PERMIT

SEWAGE DISPOSAL SYSTEM
HOWARD COUNTY HEALTH DEPARTMENT
BUREAU OF ENVIRONMENTAL HEALTH
410-313-2640

P 515030-C

SUBDIVISION Harless Manor LOT NUMBER 13 ADDRESS 14033 Monticello Drive

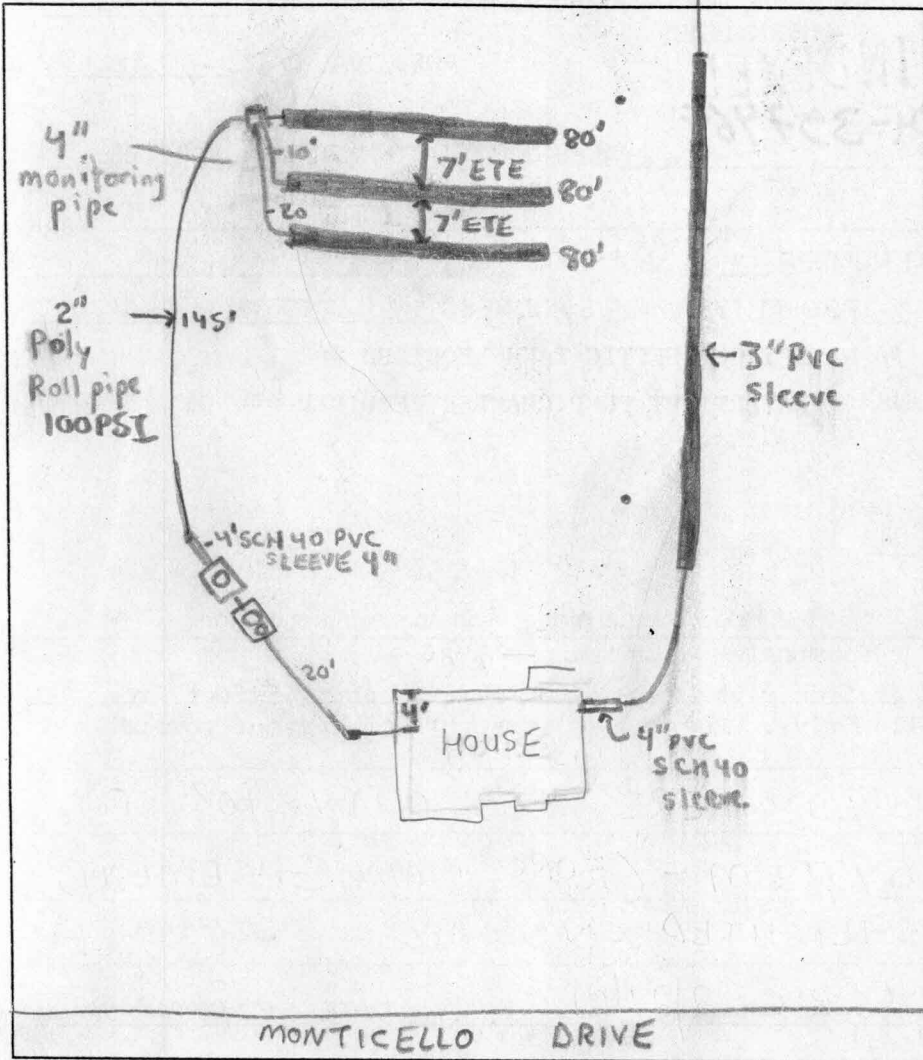
PRE-CONSTRUCTION INSPECTION: 5/7/01 - PLUMBING SET TO OTHER SIDE OF HOUSE, OK TO PUT D-BOX IN UPPER LEFT CORNER OF SDA AND RUN 3-80' TRENCHES - (OK SRW)

INSPECTION COMMENTS: 5/10/01 - OK TO COVER ALL WORK, STILL NEED HOUSE CONN. & PUMP TEST - (SRW) 6/12/01 Pump and alarm working. Robert said house connection was made. (BB)
